RELOCATION OF GATES 10 & 11

**PROJECT NO. 54 1019 1765
CONTRACT NO. 54-2-20-2111**

ADDENDUM NO. 1

March 27, 2020

BID DOCUMENTS
DRAWING 0003
PROJECT 54 1019 1765
SHEET 3 OF 127

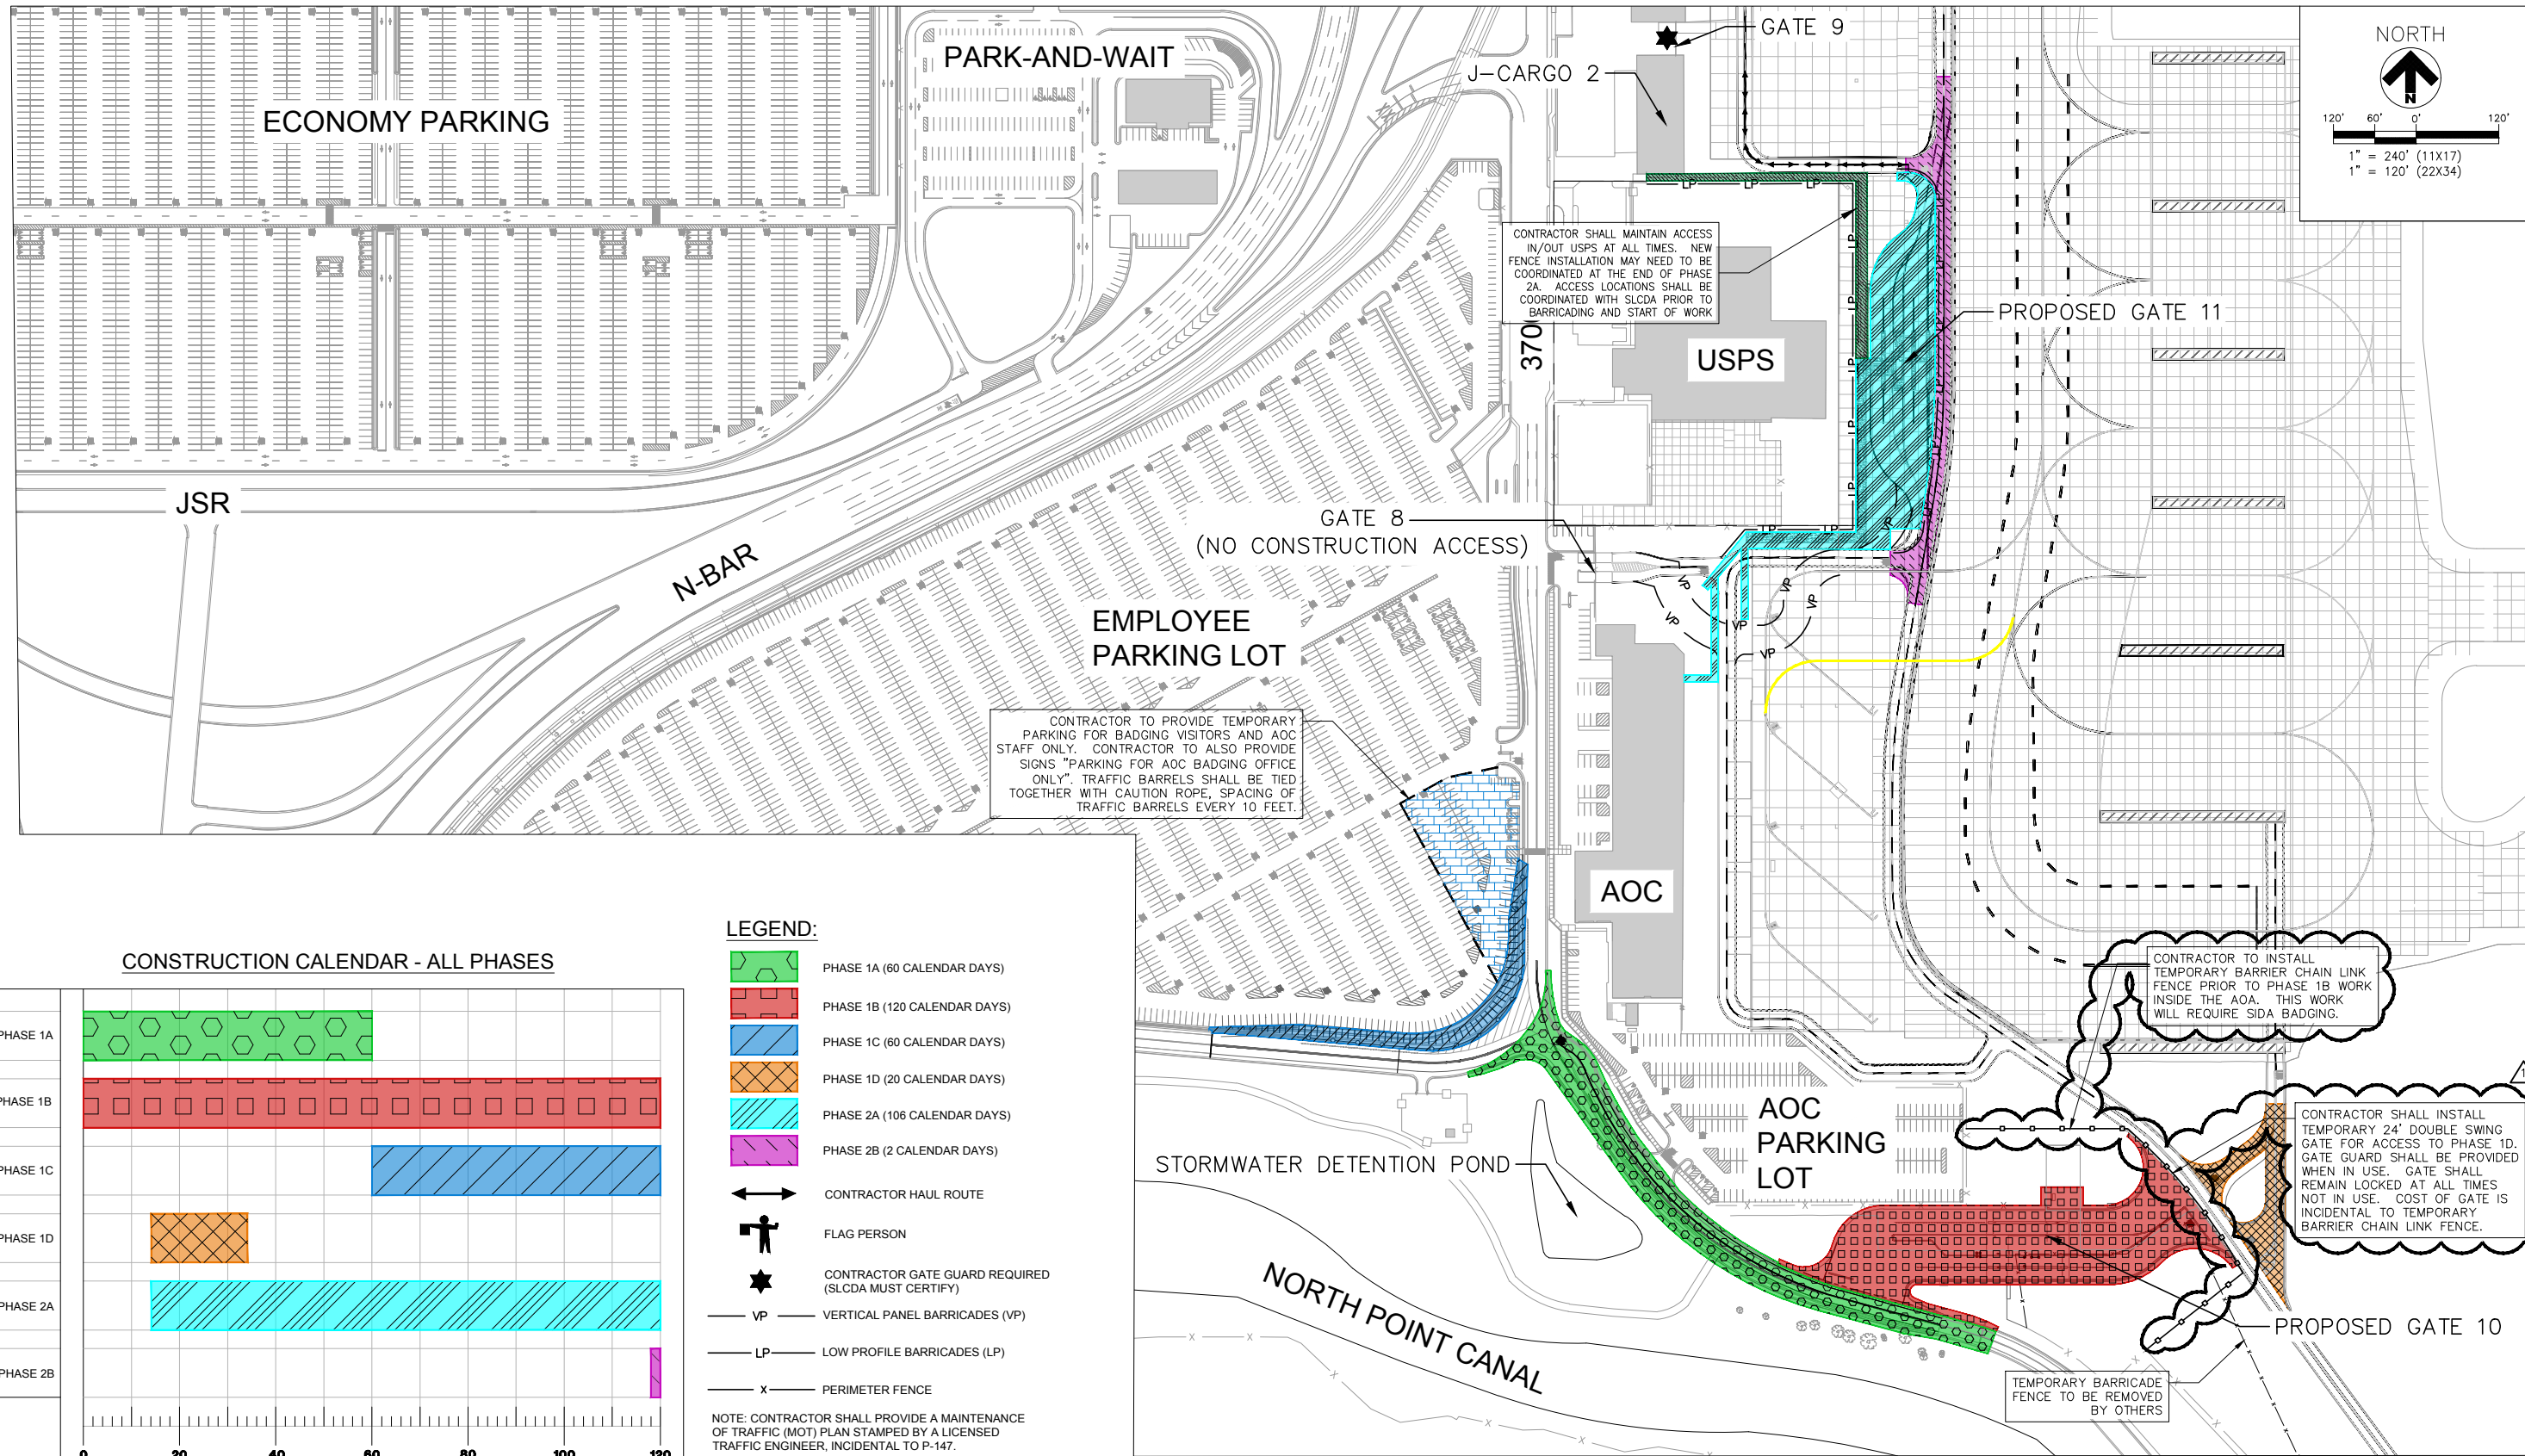
Question 5 - Plan sheet G003 references the Safety Plan Narrative for a different project. Are there any additional or differing restrictions for this project?

G003 Addendum No. 1 - Revised Safety Plan Narrative Notes 1 and 2.

Answer - The Safety Plan Narrative will be corrected in Addendum No. 1 so that it reflects this projects work. It should be noted that there will not be any additional information that isn’t already covered in the Project Documents.

DRAWING G015
PROJECT 54 1019 1765
SHEET 6 OF 127

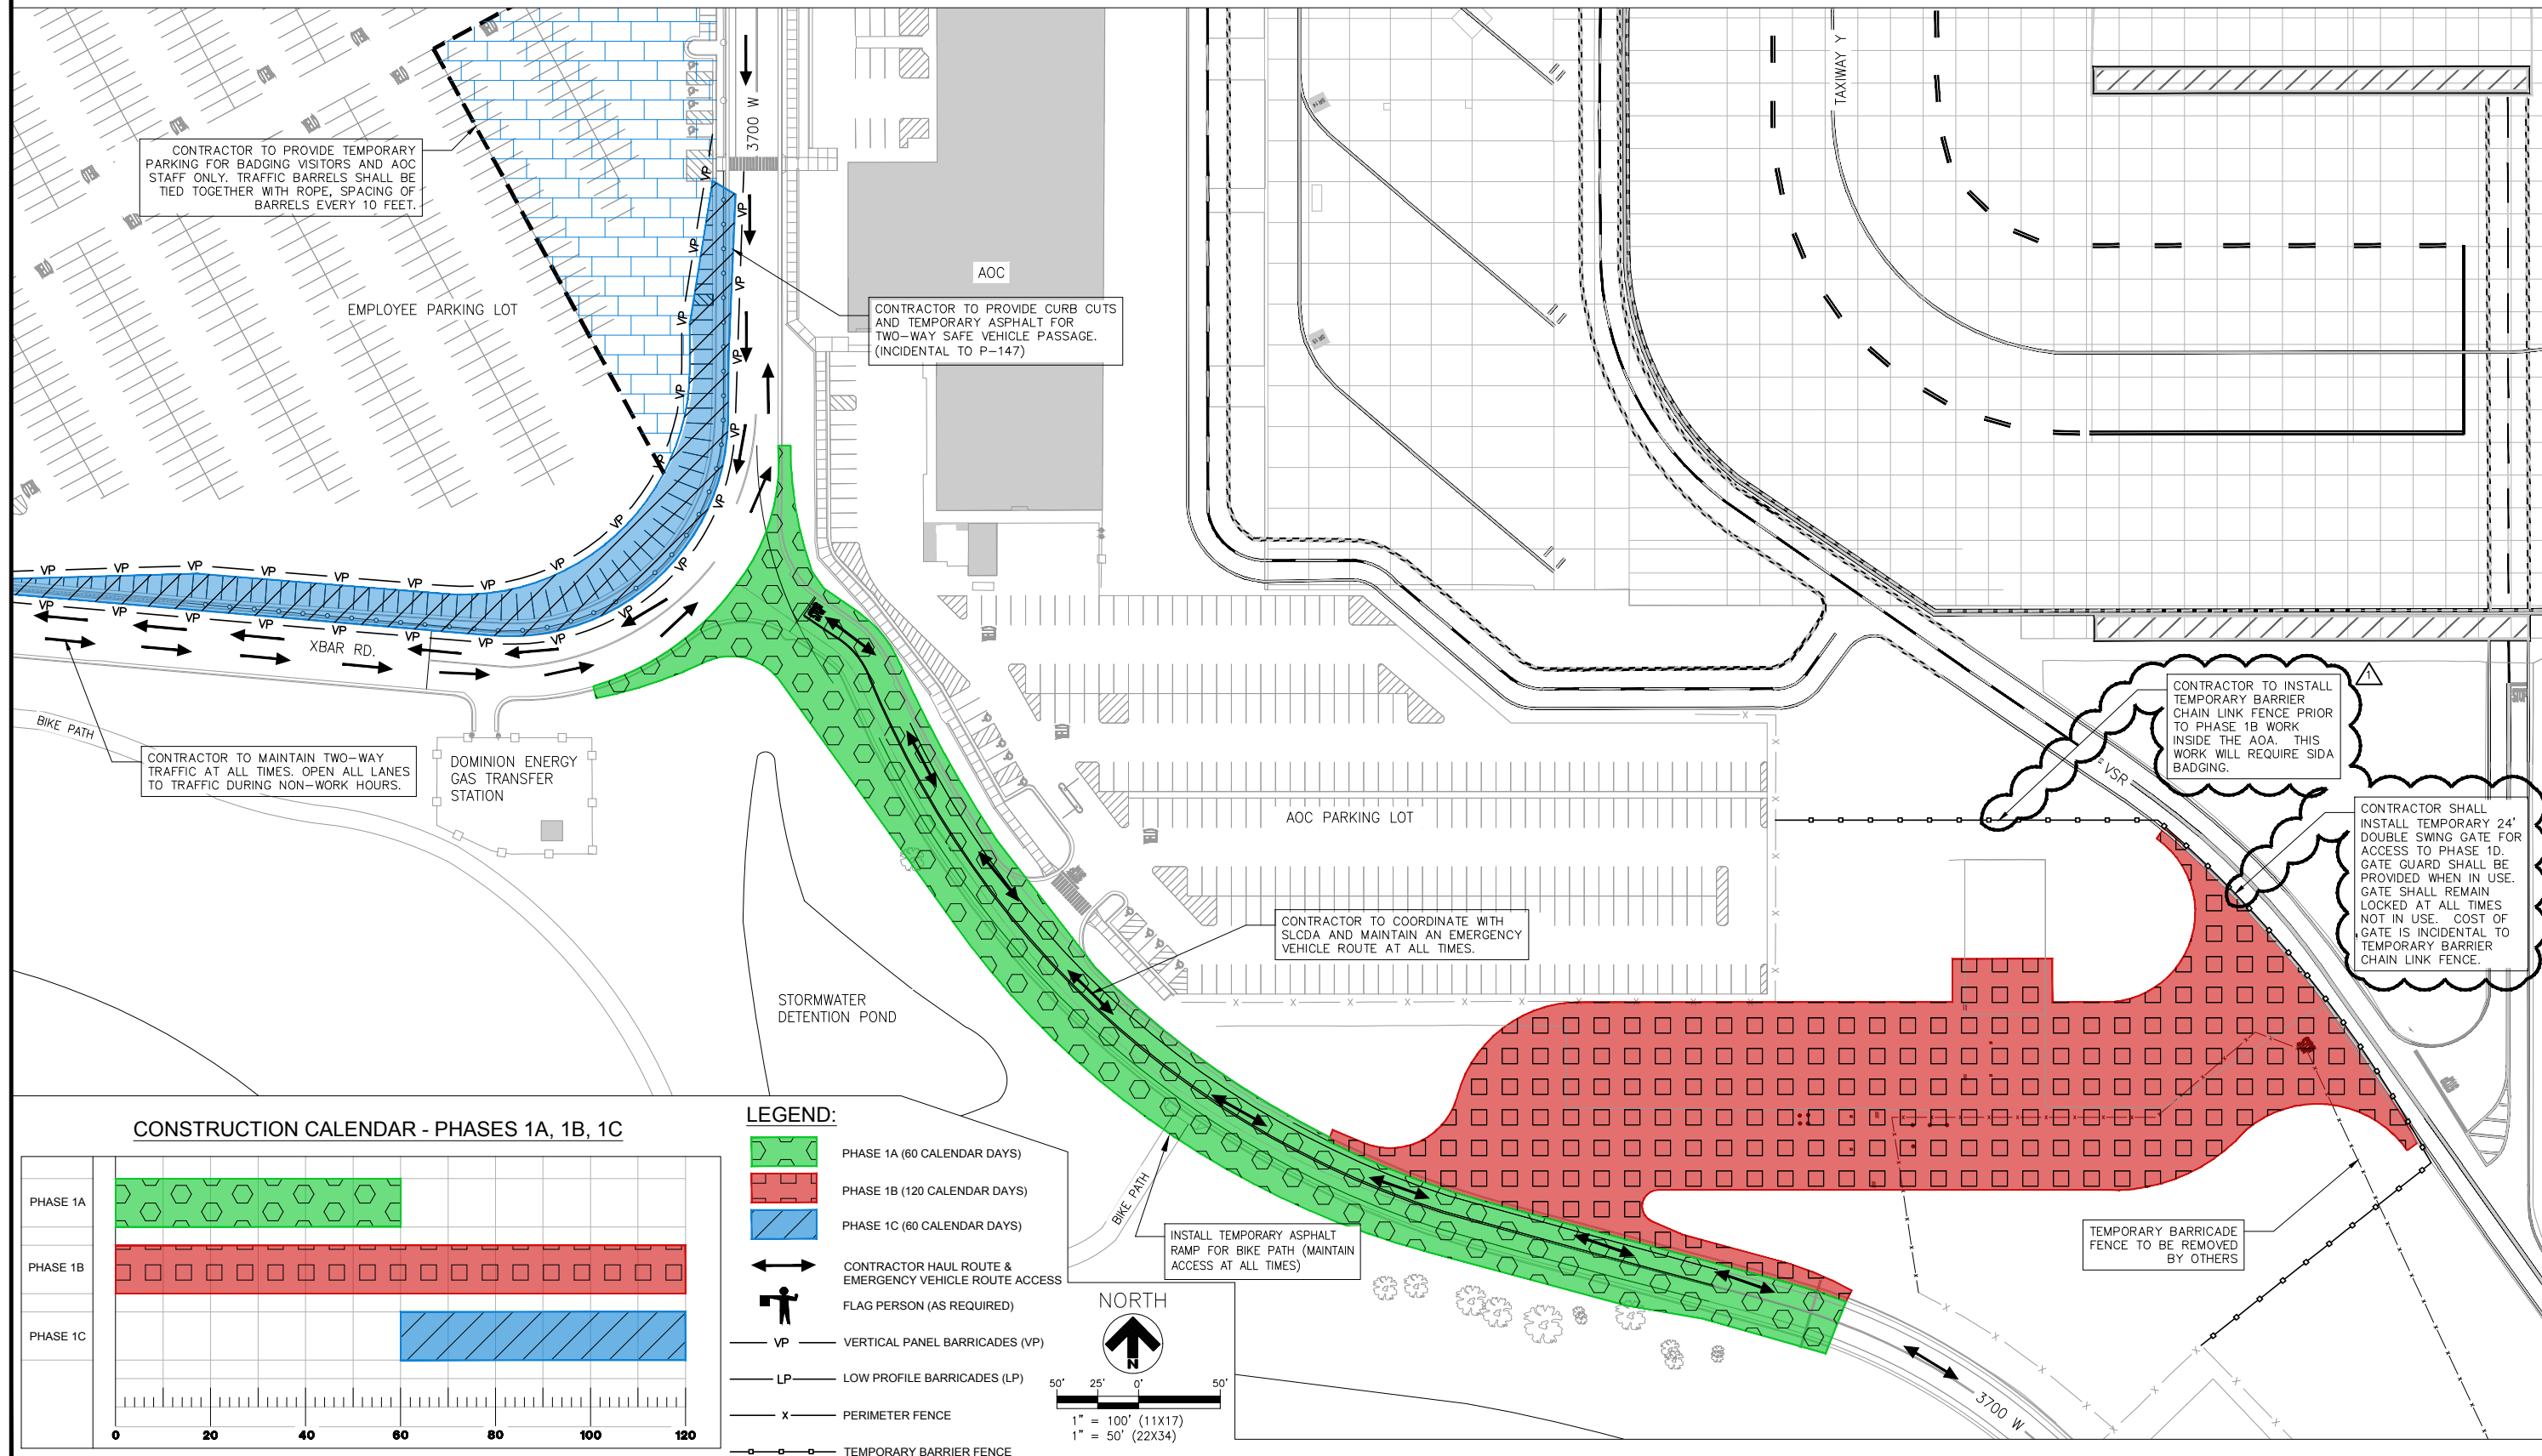
G015 Addendum No. 1 - Added call outs for Temporary Barrier Chain Link Fence and Temporary 24' double swing gate on Phase 1B for Phase 1D access. Also showed new chain link fence work in Phase 2A as a different color for a coordinated activity.

BID DOCUMENTS
DRAWING G016
PROJECT 54 1019 1765
SHEET 7 OF 127

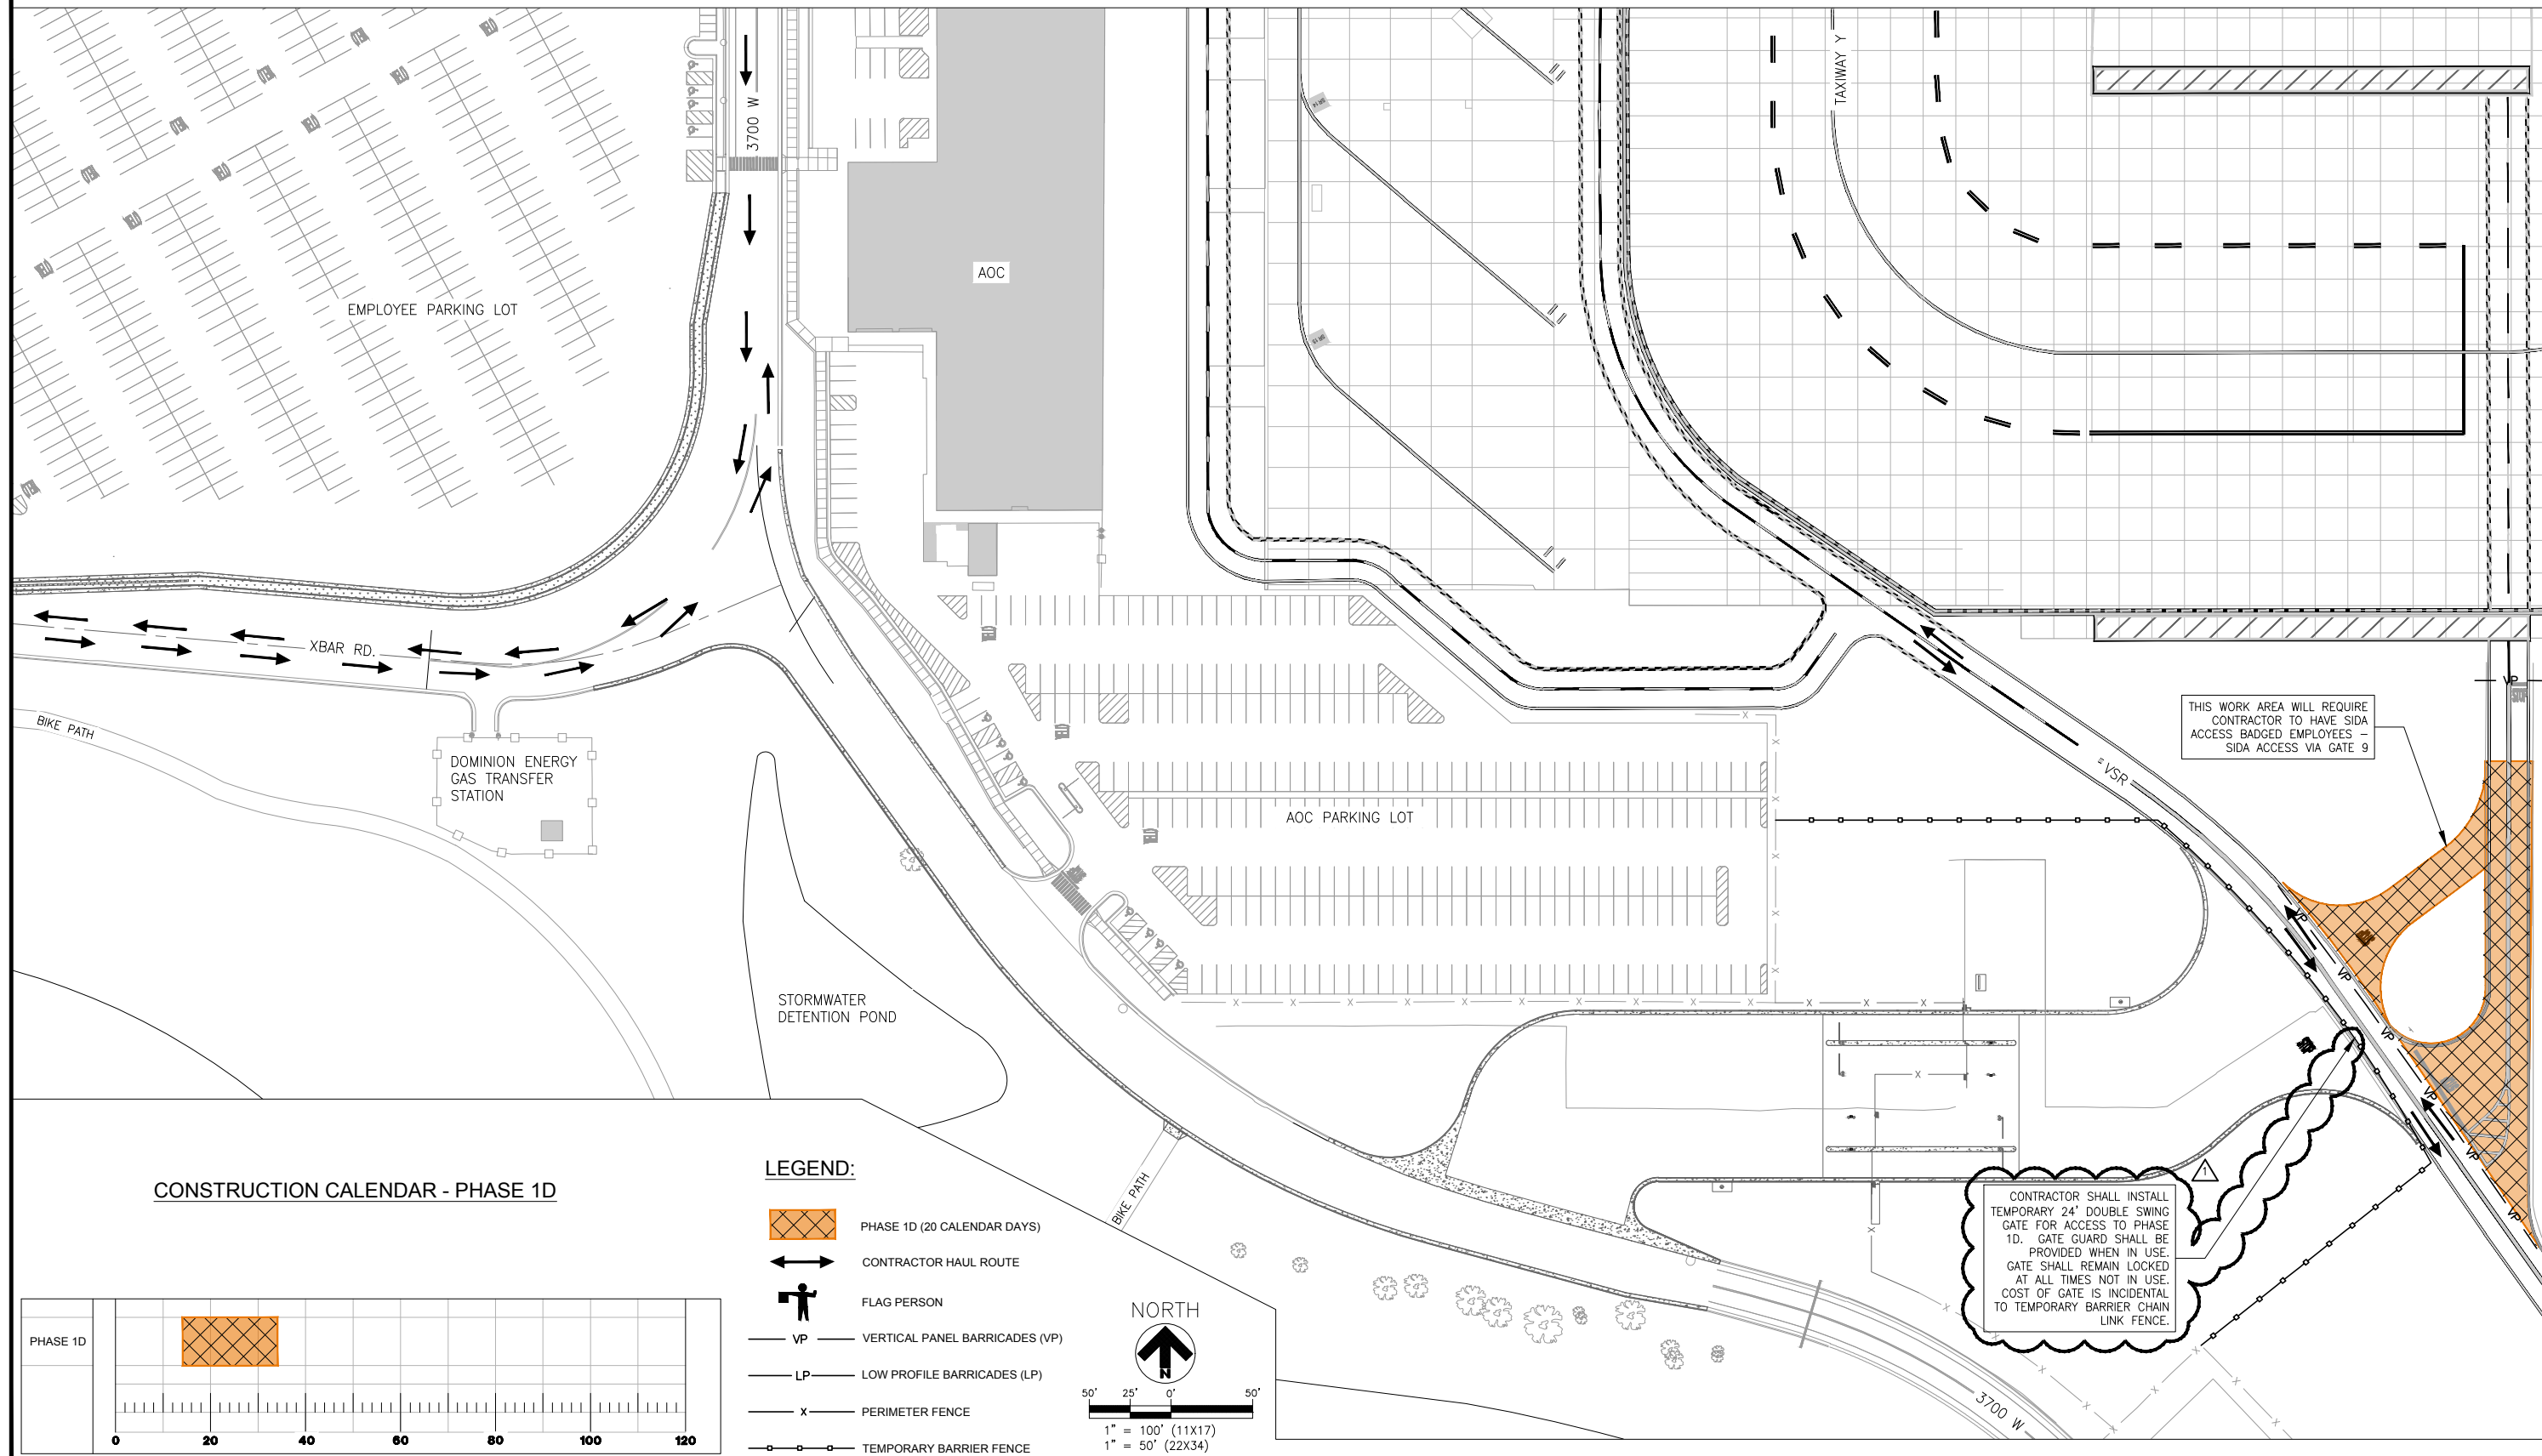
G016 Addendum No. 1 - Added call outs for Temporary Barrier Chain Link Fence and Temporary 24' double swing gate for Phase 1B for Phase 1D access.
